REQUEST FOR PROPSAL

PROJECT #: 656-21-236		PROJECT NAME: EHRM Admin & Training	
PROPOSAL DUE DATE:		TIME DUE:	PROPOSAL SENT TO:
Tuesday January 17		12:00PM CST	thagen@mdmconst.com dnotch@mdmconst.com
PURPOSE:		PREPARED BY:	DATE ISSUED:
RFI and Bulletins		Trent Hagen	1/6/2023

ST. CLOUD VA HEALTH CARE SYSTEM
ST. CLOUD, MN.
PROJECT NAME: EHRM Training & Admin Support
VA PROJECT NO: 656-21-236
BAE NO: 18-116

CONSTRUCTION BULLETIN NO. 001

1 ARCHITECTURAL DEMOLITION PLAN - PARTIAL FIRST FLOOR
1/8"=1'-0"

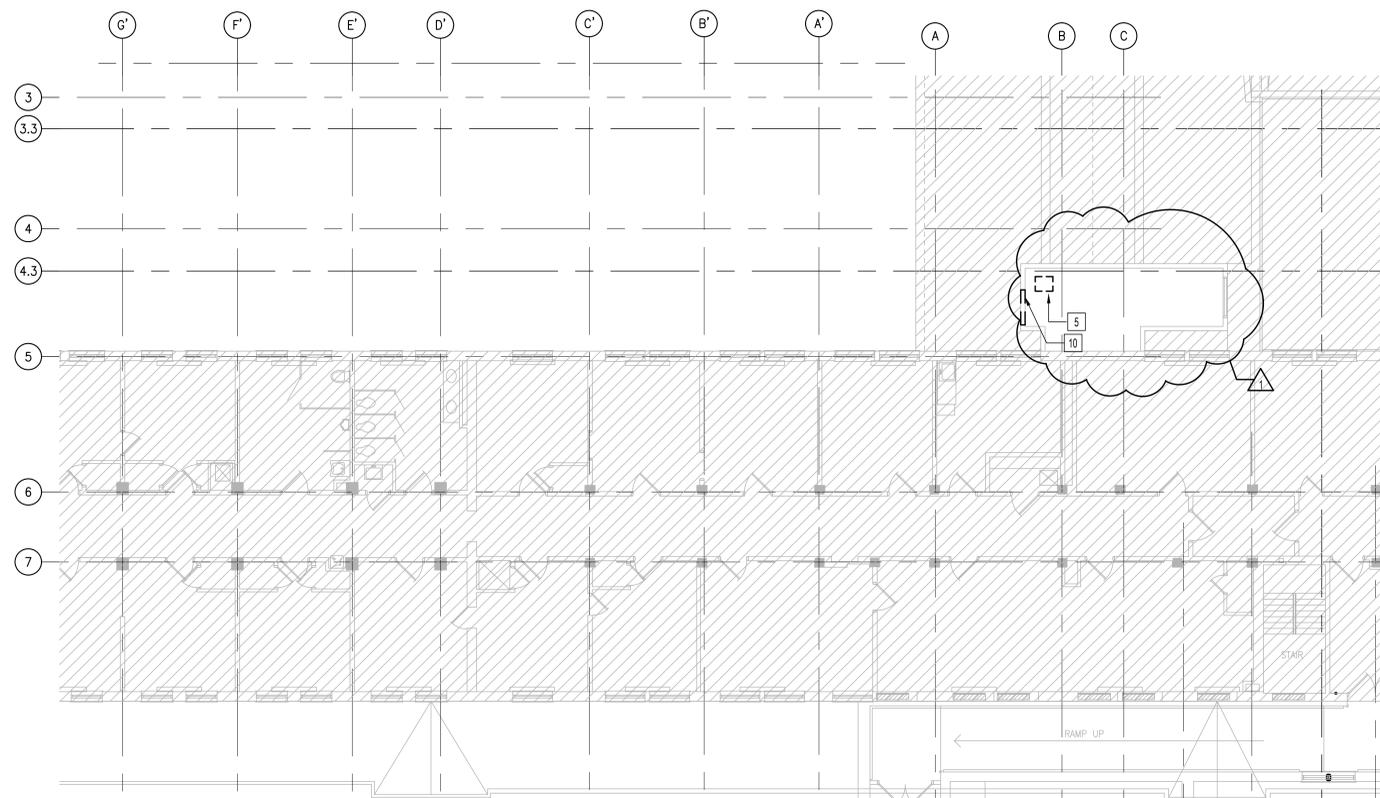
1. **AD-101**

MODIFIED 1/AD101;

Keynote 9 was added

Now Partial 2nd floor is detail 2 as both plans were labeled 1.

2/AD101 – removed Keynote 6 and added Keynote 10

Keynote 9 and 10 are added to Plan Demolition Keynotes

1 MECHANICAL - VENTILATION PLAN - FIRST FLOOR
 1/8"=1'-0"
 NORTH

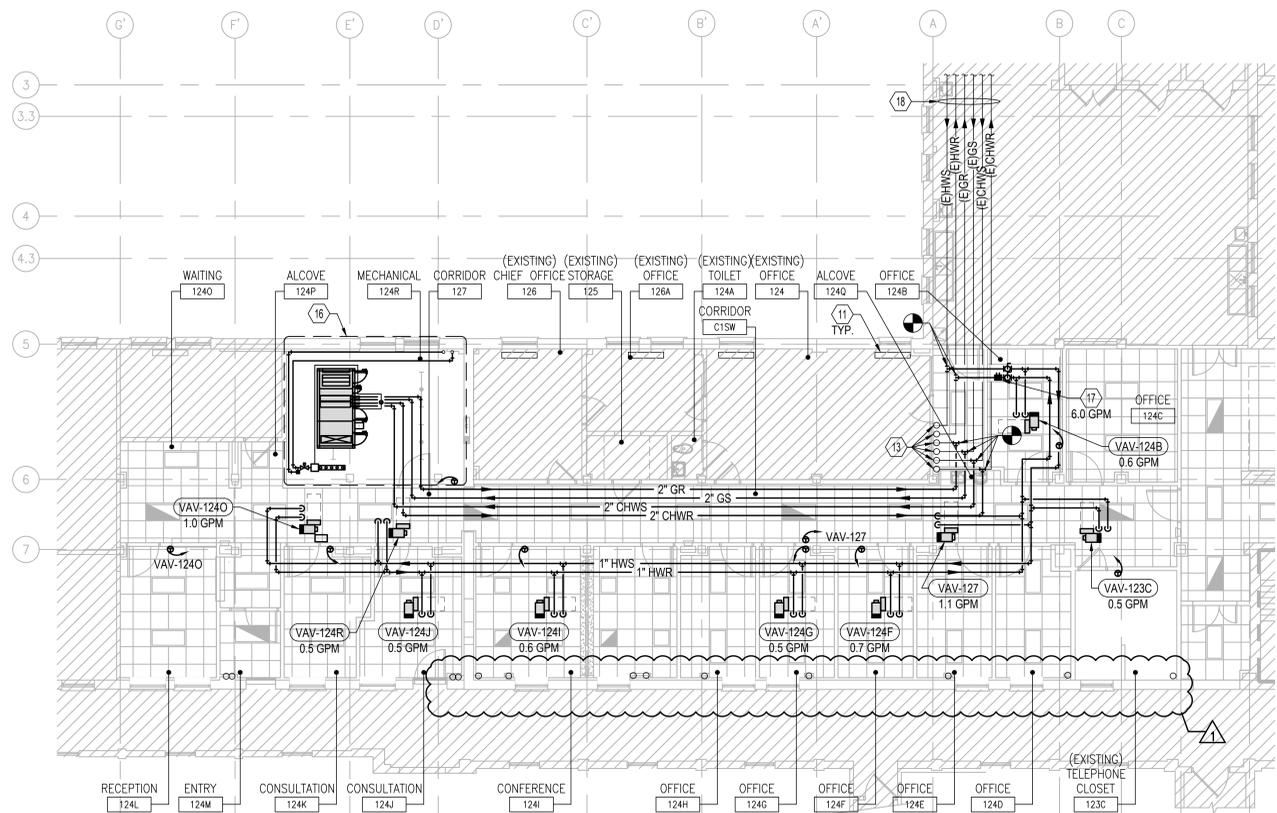
3. **M-101**

- a. Louver LV-3 relocated.
- b. Showed steam pipe risers for consistency with architectural drawing.

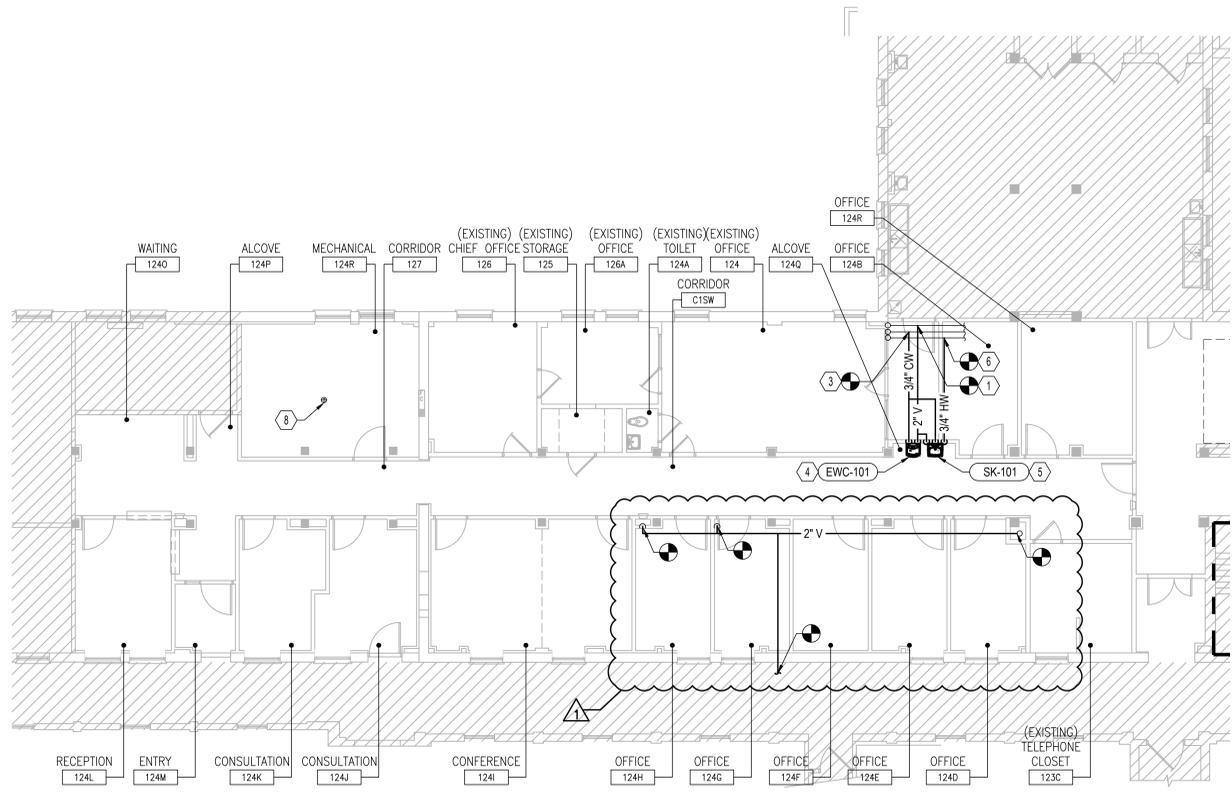
4. **M-102**

- a. Added demolition keynote 4.
- b. Updated second floor mechanical plan.

NORTH
1 PLUMBING - DOMESTIC, SANITARY + VENT PLAN - FIRST FLOOR
 1/8"=1'-0"

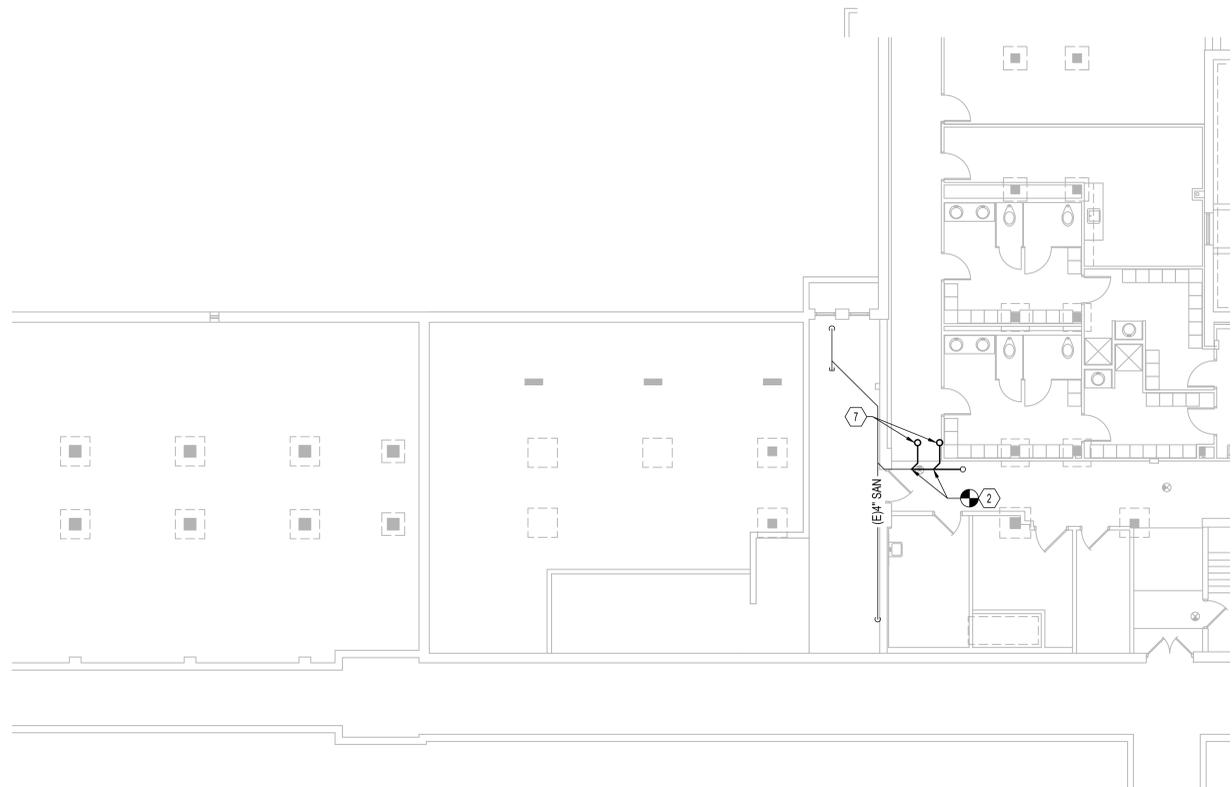
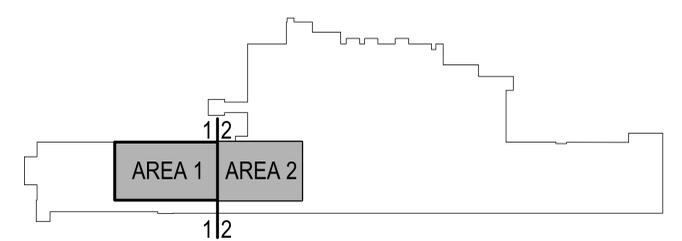
5. **P-101**

- a. Added new vent line routing.

1 PLUMBING - DEMOLITION PLAN - FIRST FLOOR
1/8"=1'-0"

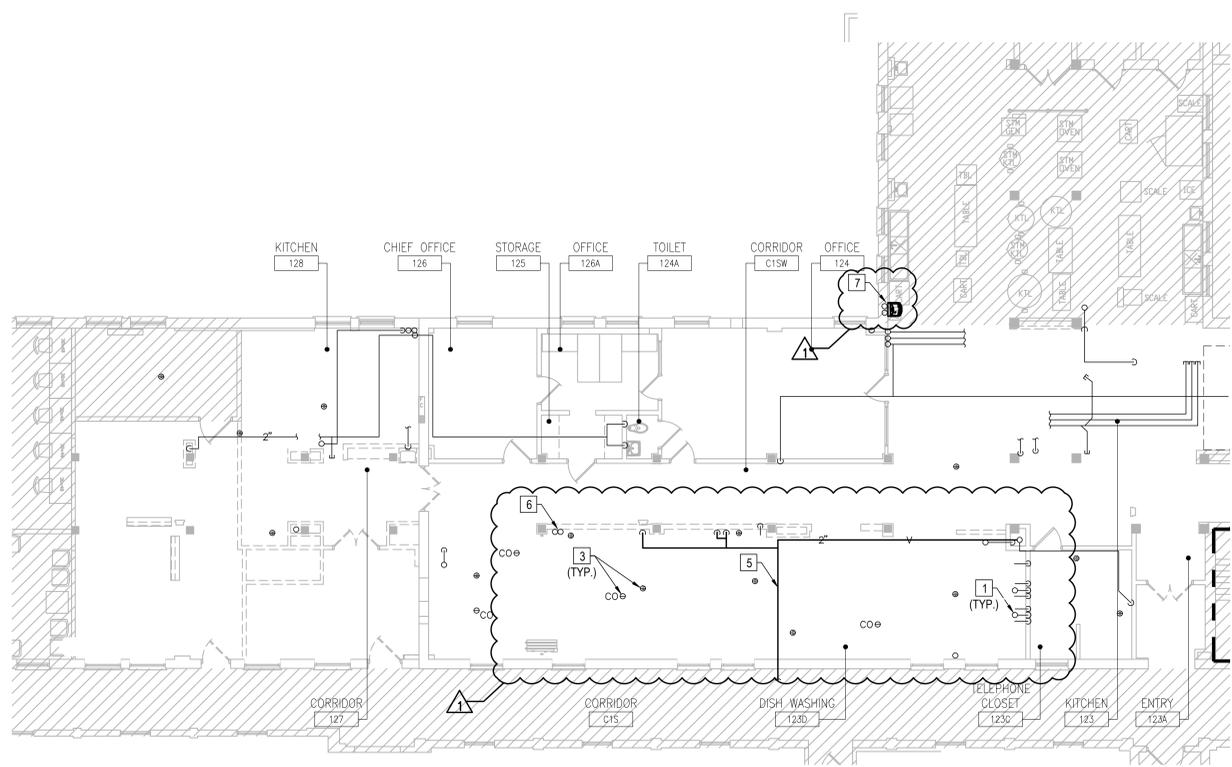
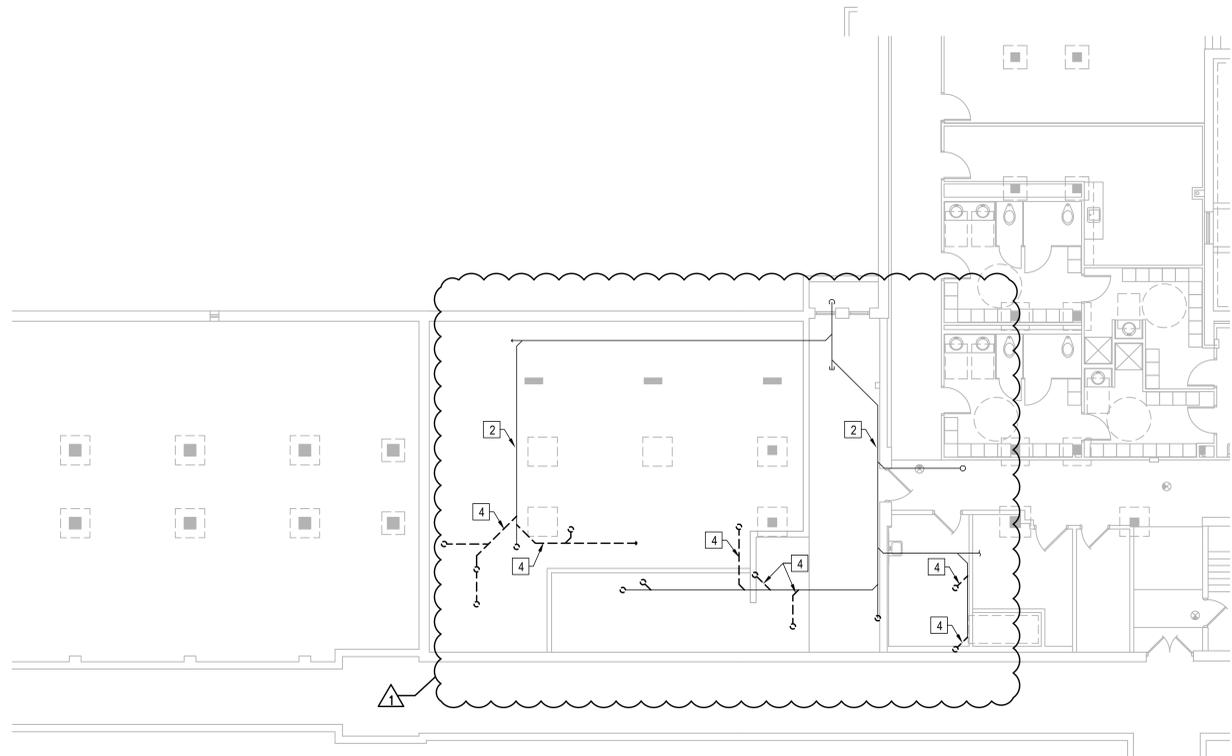
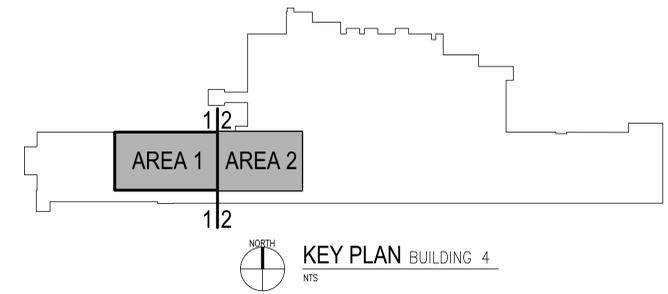
6. **PD-101**

- a. Added demolition keynotes 3,4, 5, 6 and 7.
- b. Demolished water fountain.
- c. Showed demolition extent of vent piping.
- d. Showed demolition of existing domestic hot and cold water supply.
- e. Updated basement sanitary demolition plan.

1 PLUMBING - DEMOLITION PLAN - FIRST FLOOR
1/8"=1'-0"

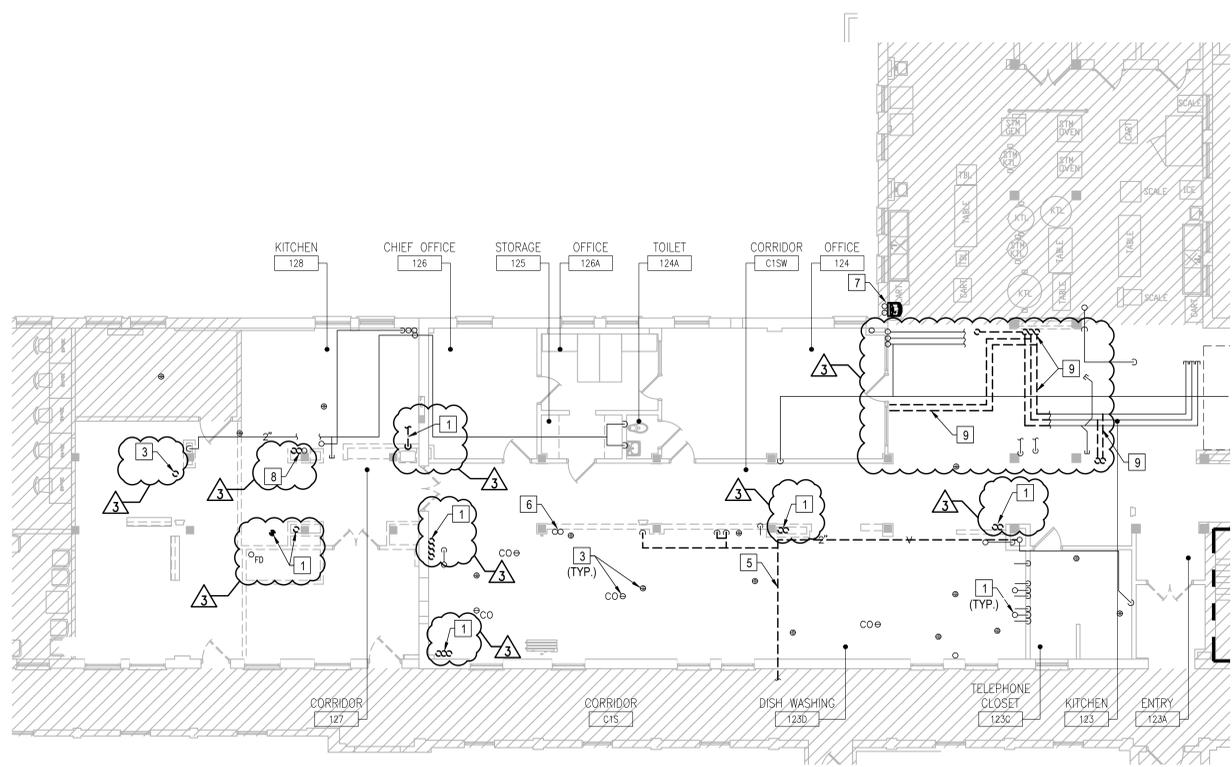
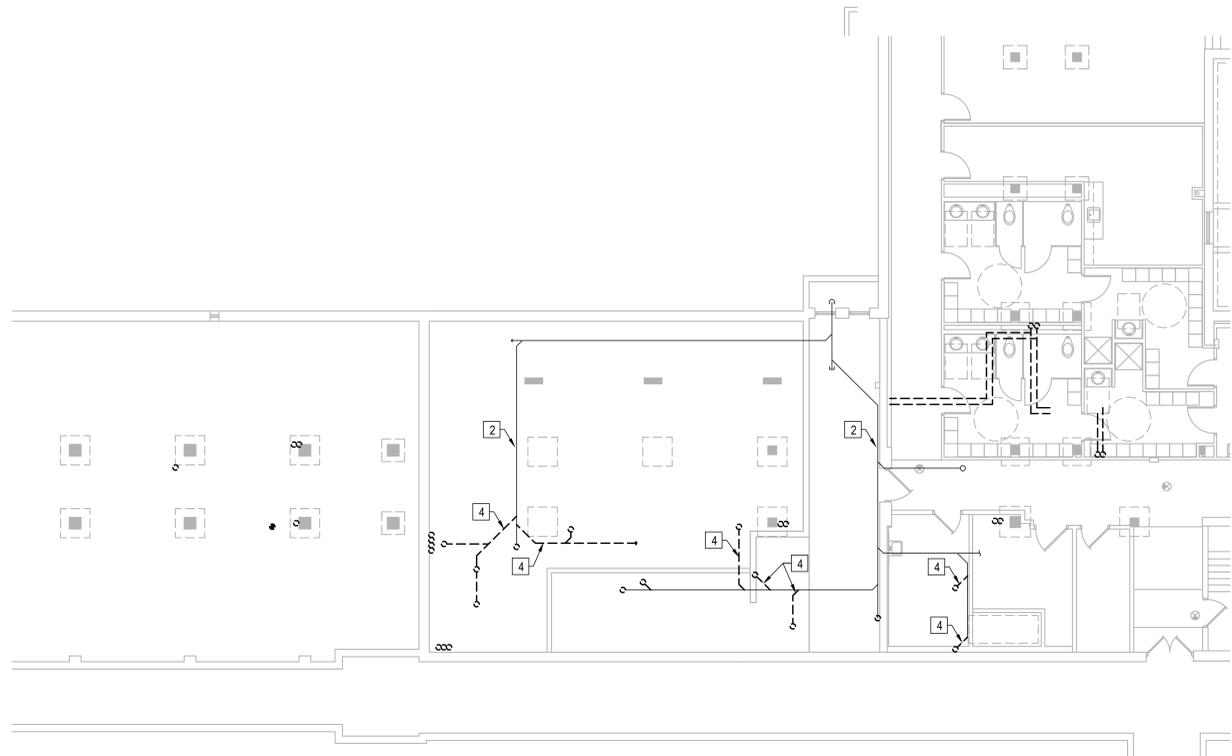
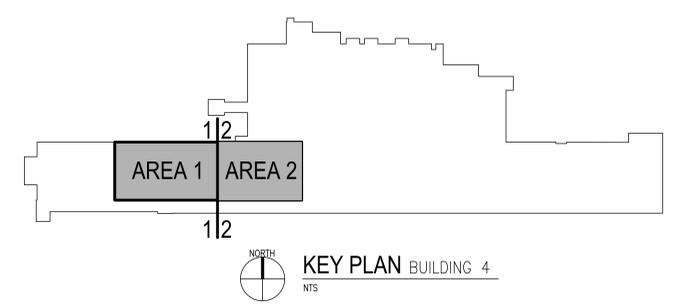
1. PD101
 - a. Included piping discovered as unforeseen conditions in the field and referenced in RFI-14. Instructions for handling pipe noted on drawings.
2. MD101
 - a. Included piping discovered as unforeseen conditions in the field and referenced in RFI-14. Instructions for handling pipe noted on drawings.

1 ARCHITECTURAL DEMOLITION PLAN - PARTIAL FIRST FLOOR

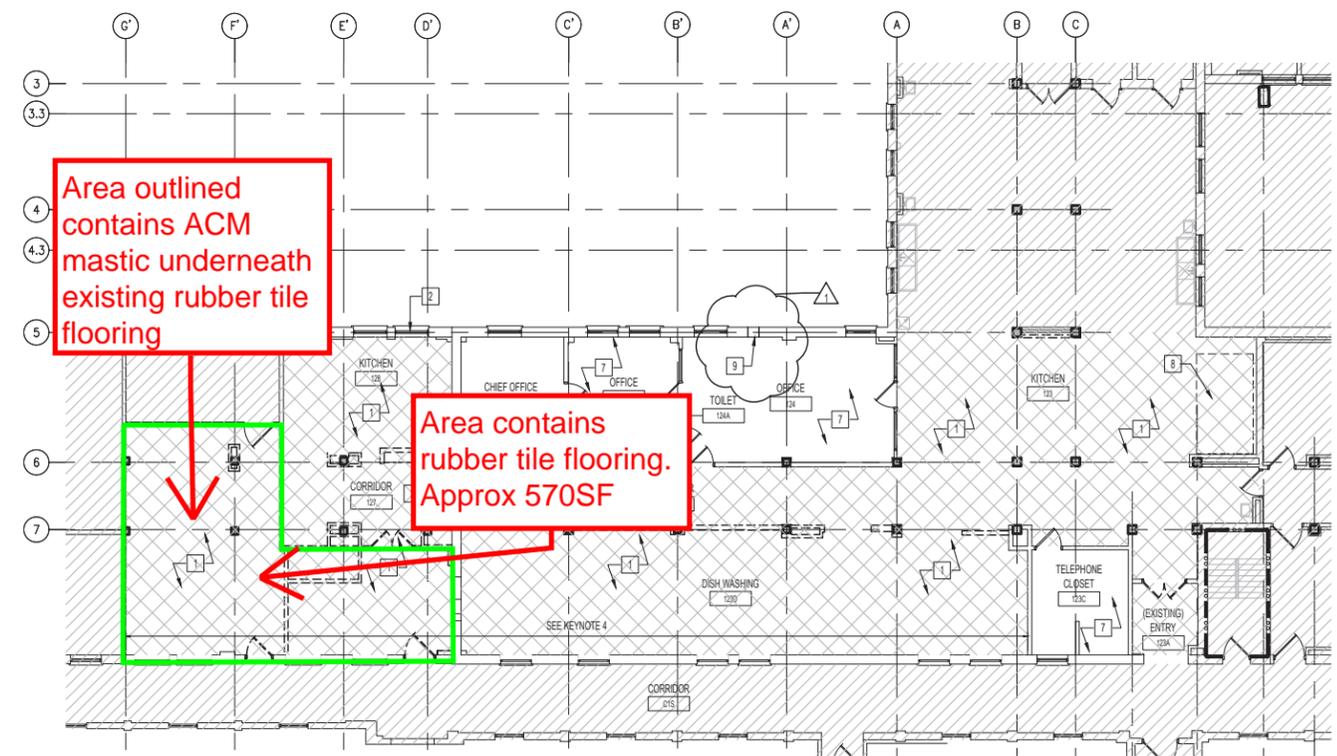
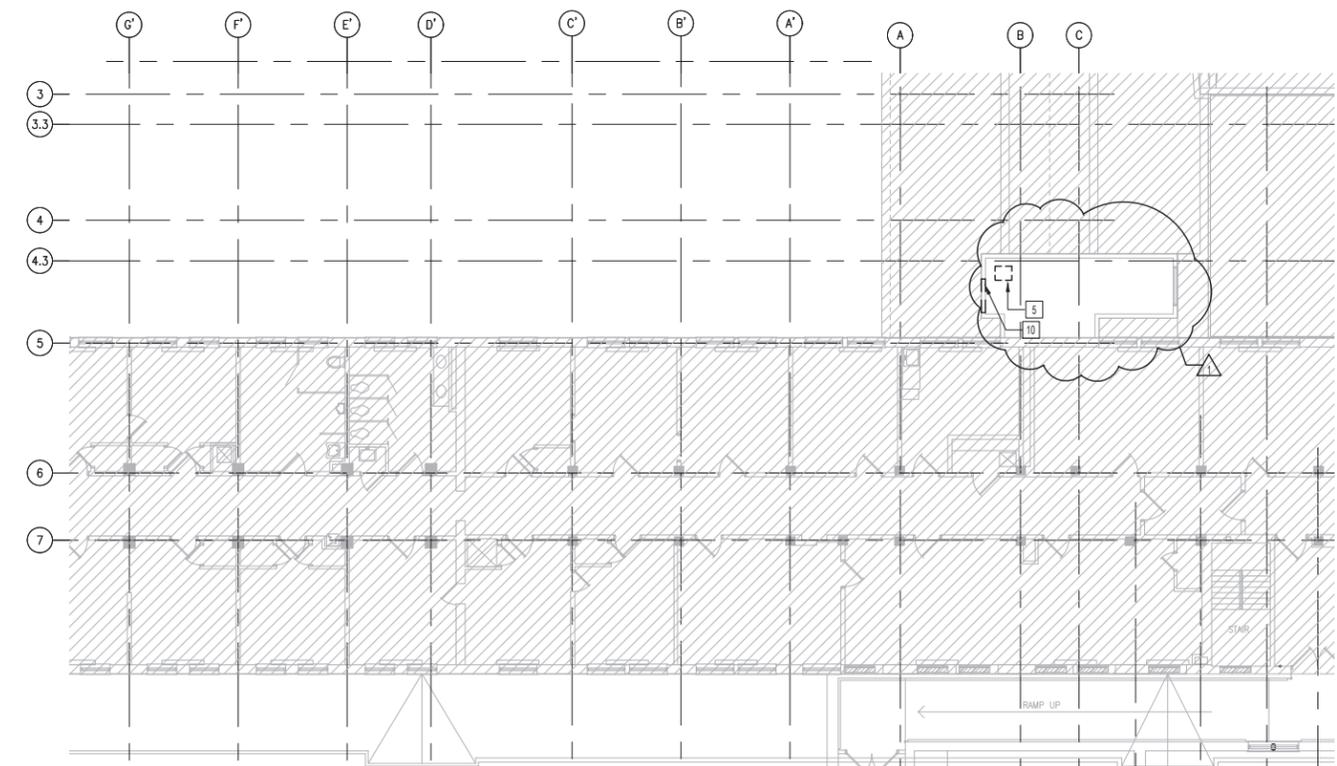
“While completing the contract glovebag abatement, several samples were taken at the area outlined in RFI #009- rubber tile flooring areas. This material has been confirmed to be asbestos containing mastic.

The outline below represents the areas that this mastic is found as well as the sampling report. Please advise as to how we should proceed.”

BAE takes no exception to abatement of the ACM mastic in the area defined in the attached sketch. Material shall be removed in a manner that complies with the attached Specification Section 02 82 13.19.
